United States Environmental Protection Agency
One Congress Street Suite 1100
Boston, MA 02114-2023

Re: Conditional Approval of GE's July 27, 2007 submittal titled *Supplement to the Pre-Design Investigation Report for Unkamet Brook*

This letter constitutes EPA's conditional approval of the *Supplement to the Pre-Design Investigation (PDI) Report for Unkamet Brook* dated July 27, 2007 (the "Supplement"). This Supplement is subject to the terms and conditions specified in the Consent Decree (CD) that was entered in U.S. District Court on October 27, 2000.

**FIGURE 1
 UNKAMET BROOK - FORMER WEST AREA
 ASPHALT INSPECTION PHOTO LOCATIONS
 1 AUGUST 2007**

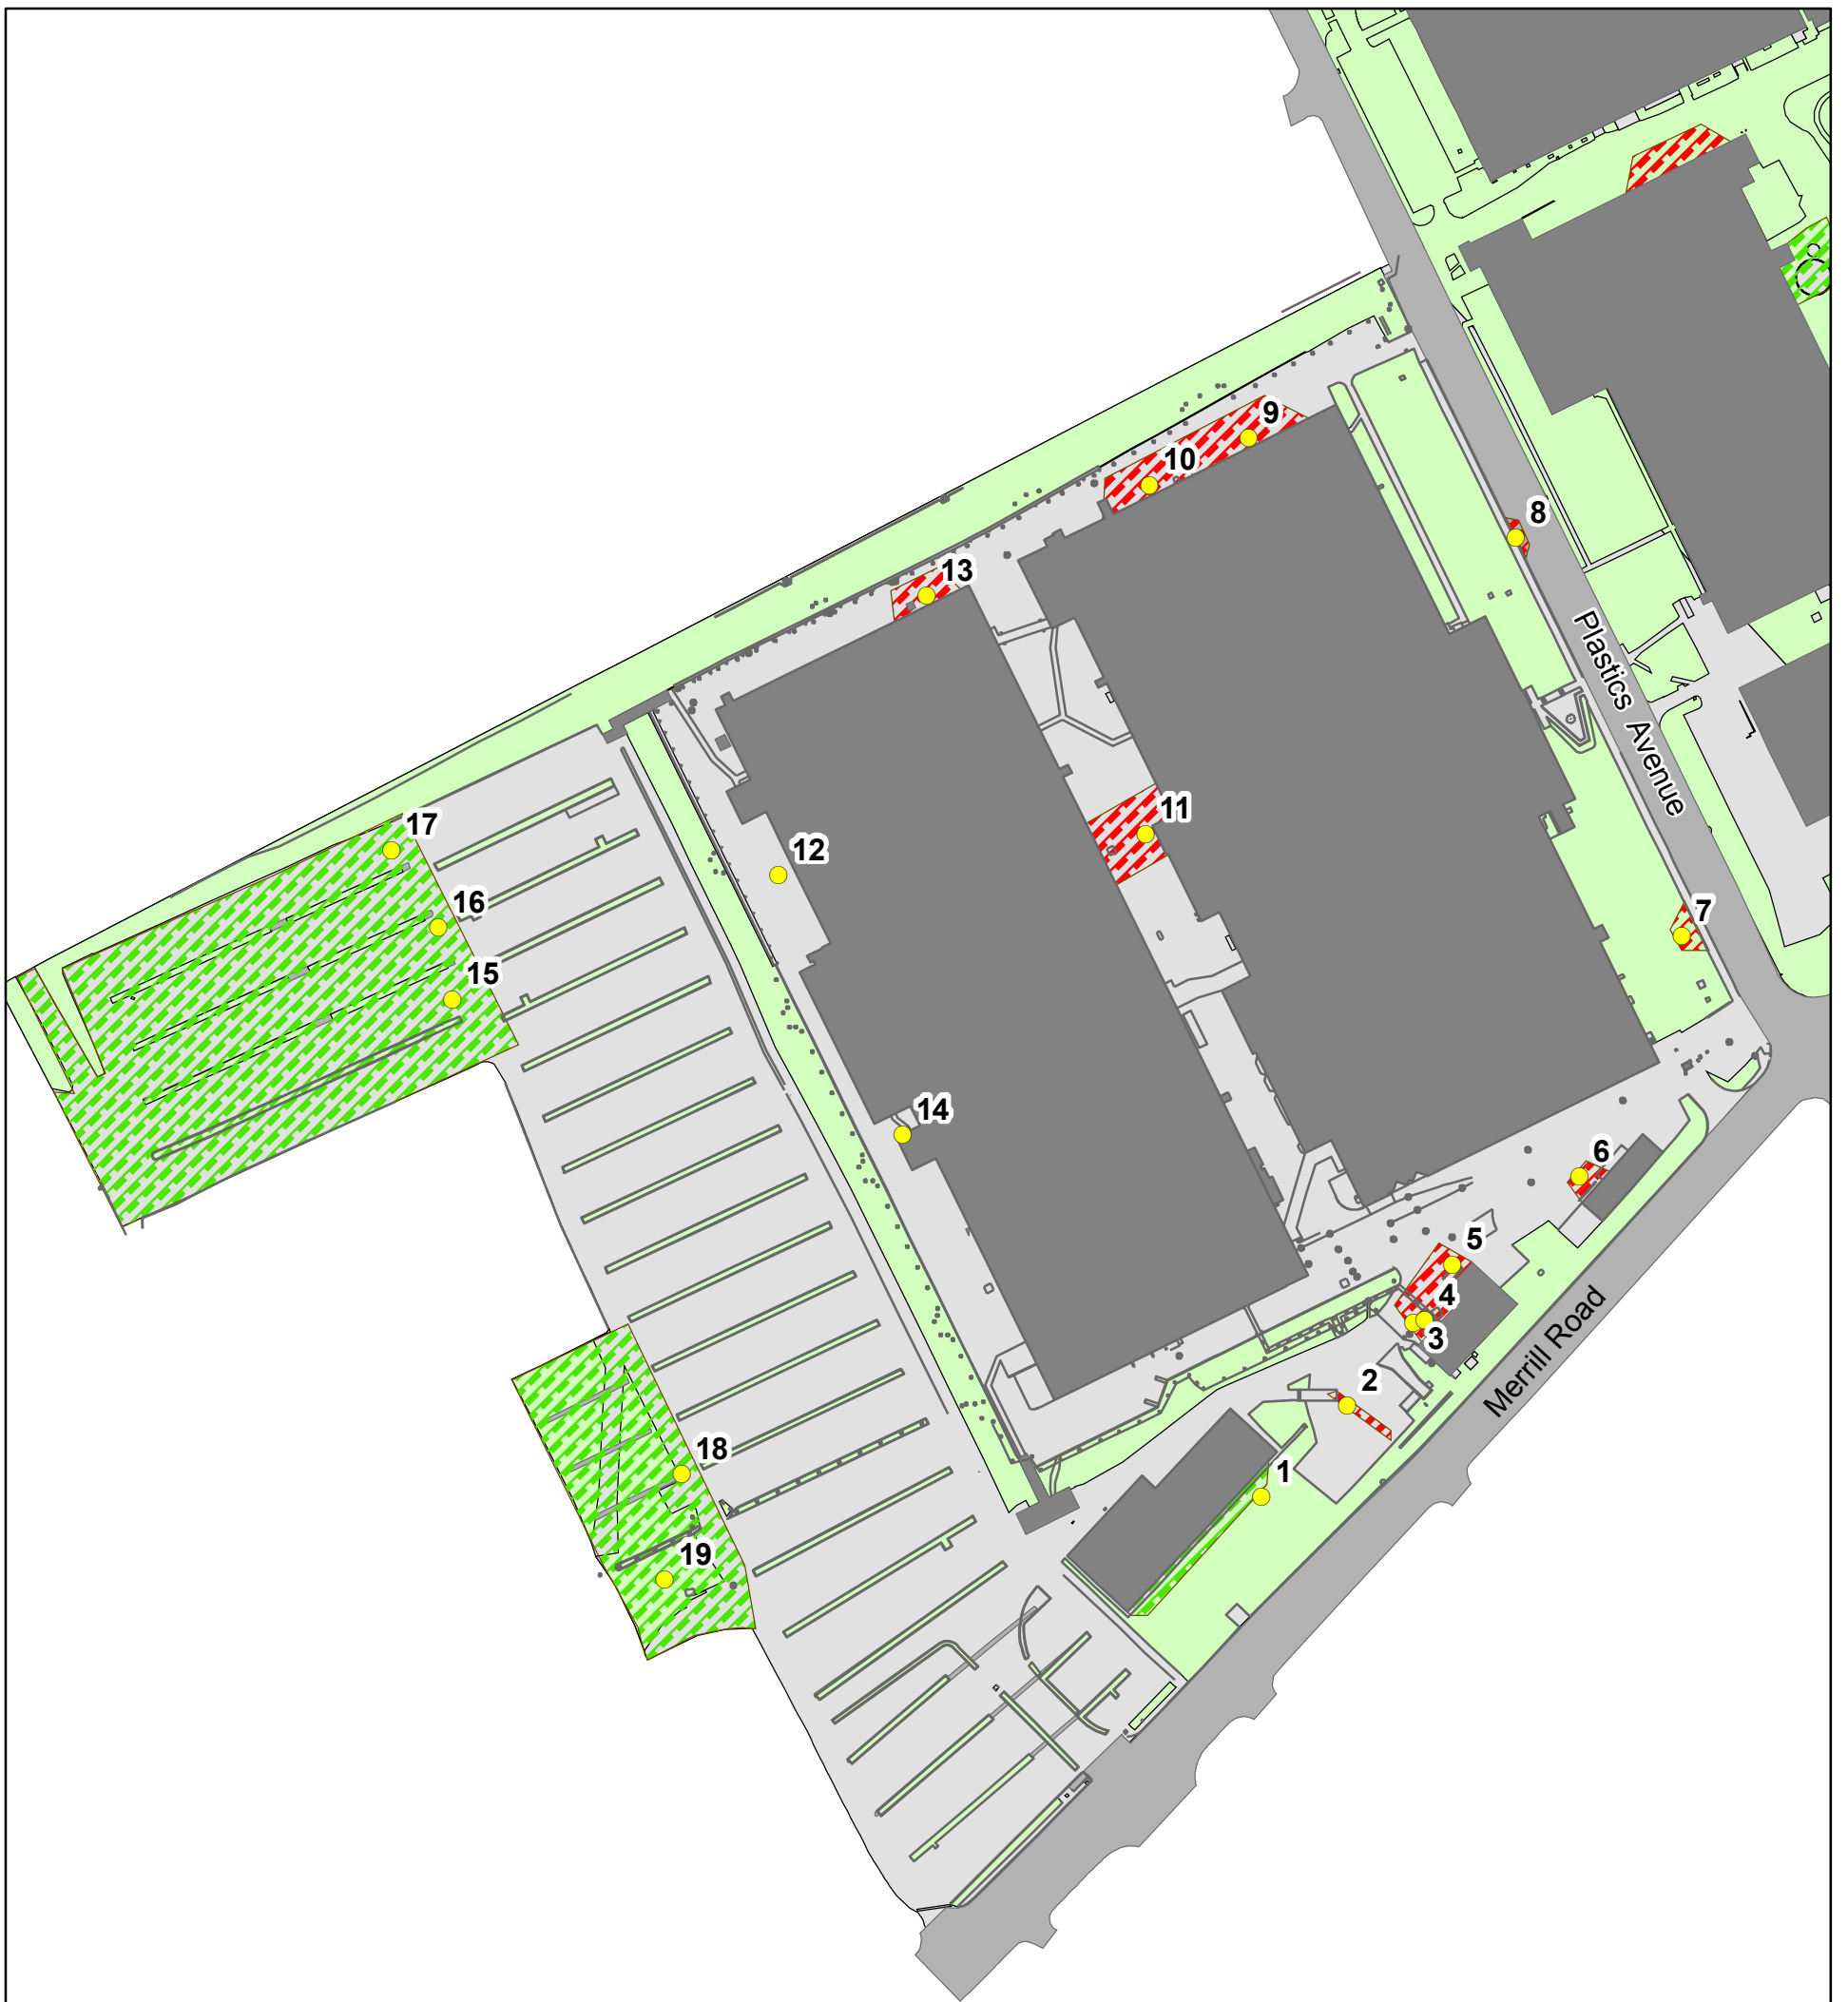
2. A site walk to determine the extent of paved areas and areas of degraded pavement was conducted on August 1, 2007 by EPA and their consultant and GE's consultant. Three figures are attached that indicate EPA's classification of the condition of the pavement in certain areas following the site walk. The figures classify the Removal Action Area ("RAA") into three separate categories: (i) "Unpaved," (ii) "Degraded Pavement," or (iii) "Paved." In the Second Supplement (described below), GE shall submit (a) revised figures for the entire RAA that clearly identify the areas that have been or will be characterized as unpaved, the areas that have been or will be characterized as paved, and the areas that have not been characterized, including existing buildings and building foundations, (b) an evaluation showing how the unpaved and paved areas on GE-owned properties and how the non-GE-owned properties meet the characterization requirements, (c) a proposal for additional sampling as necessary to meet the applicable characterization requirements, and (d) a proposal for the

restoration of degraded pavement on GE-owned property if GE elects to characterize these areas as paved, including a timeline and a figure showing all areas that will be restored. If GE elects not to restore degraded pavement on GE-owned property, then GE shall characterize such areas as unpaved and identify the areas as such in the Figures.

For non-GE-owned areas, GE shall identify paved areas, unpaved areas, and areas of degraded pavement. Although the classification of paved vs. unpaved areas in non-GE-owned properties does not affect the characterization requirements, it may affect remediation requirements. In degraded pavement areas, GE may have to repair, inspect, and maintain such pavement if GE elects to leave in place a not-to-exceed polygon located beneath degraded pavement.

**FIGURE 2
UNKAMET BROOK - FORMER NORTH AREA
ASPHALT INSPECTION PHOTO LOCATIONS
1 AUGUST 2007**

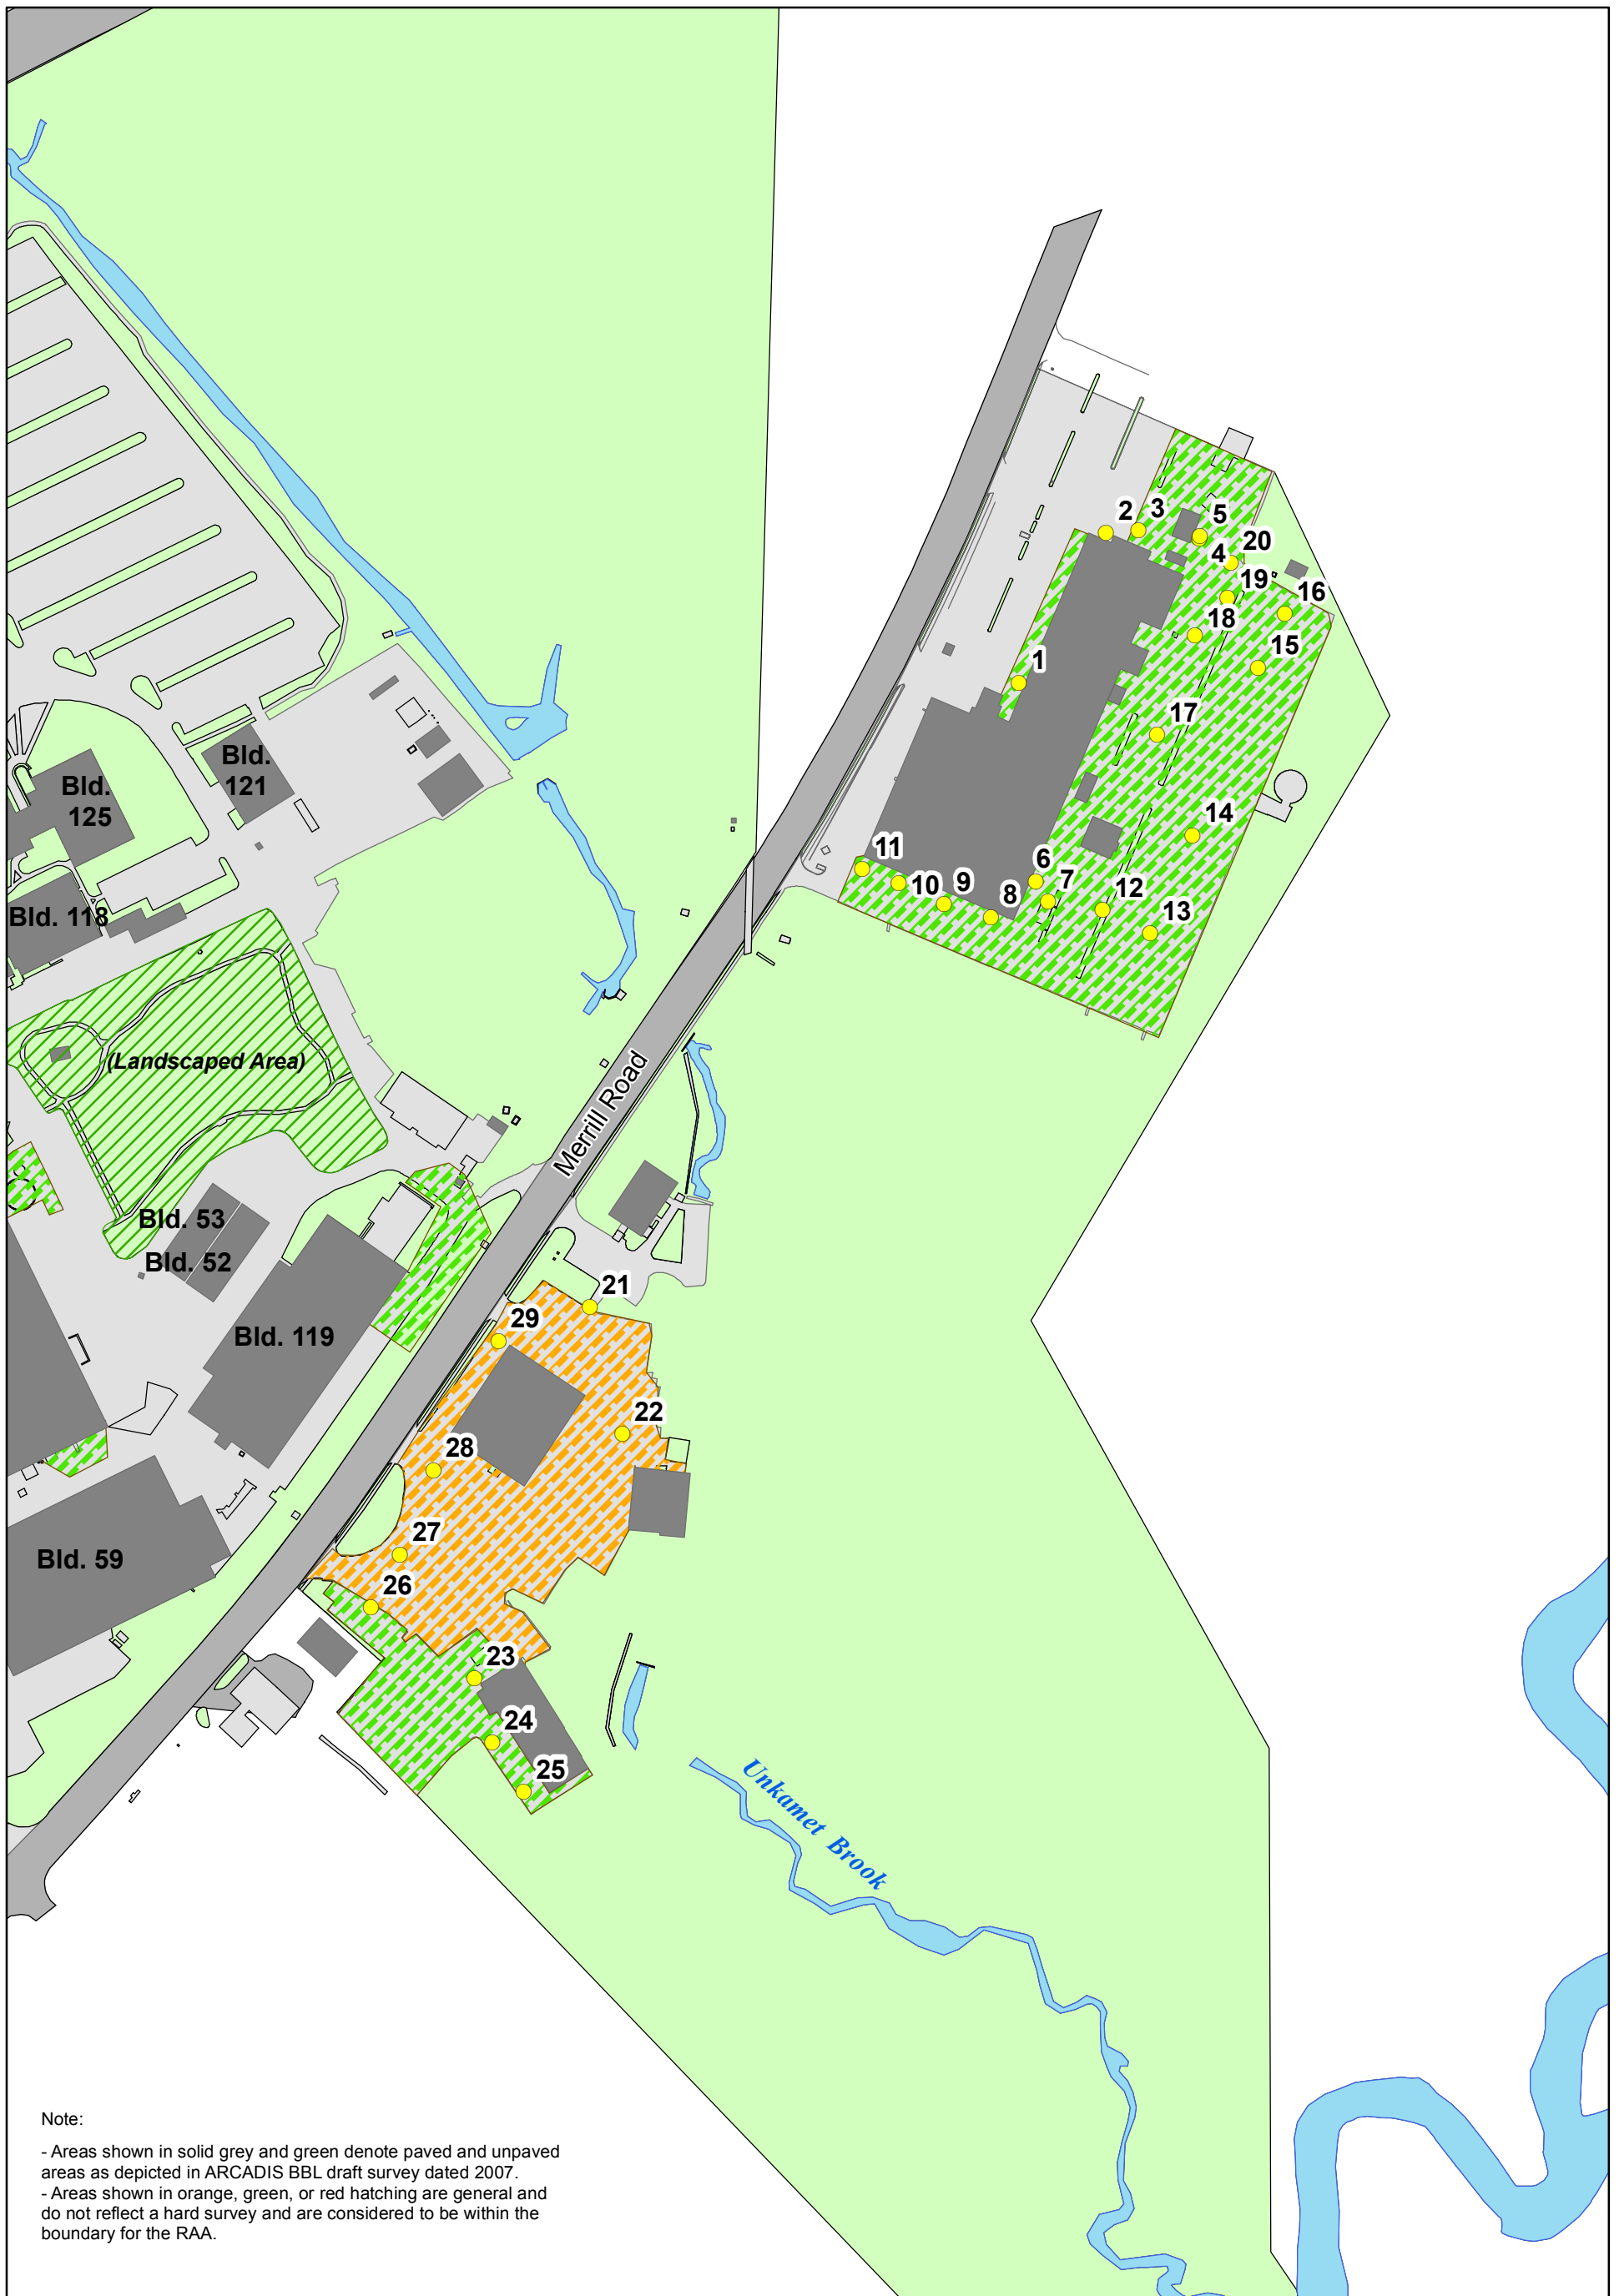
4. GE shall submit information and data that describes the nature and extent of the surface cover within the portion of Parcel K12-9-1 depicted in attached Figure 2 as a landscaped area, prior to the covering of the area with fill. The information and data shall demonstrate and identify specific areas that were paved or unpaved, the integrity of the building slabs and paved ground cover, and the extent of characterization sampling conducted prior to the placement of fill. If any areas within the landscaped area were unpaved prior to the placement of fill or if GE cannot provide sufficient information to demonstrate that certain areas were paved or were covered by building foundations that were in acceptable condition, then GE shall demonstrate that such unpaved areas meet the unpaved sampling grid requirements. If it is determined that the unpaved sampling grid requirements were not met, then GE shall propose additional sampling of such areas that meets unpaved grid and depth sampling requirements.

In addition, GE will be required to maintain the integrity of the soil cover over areas determined to be paved/building slabs (or the underlying pavement/slabs should the soil cover be removed) for the purpose of meeting Performance Standards.
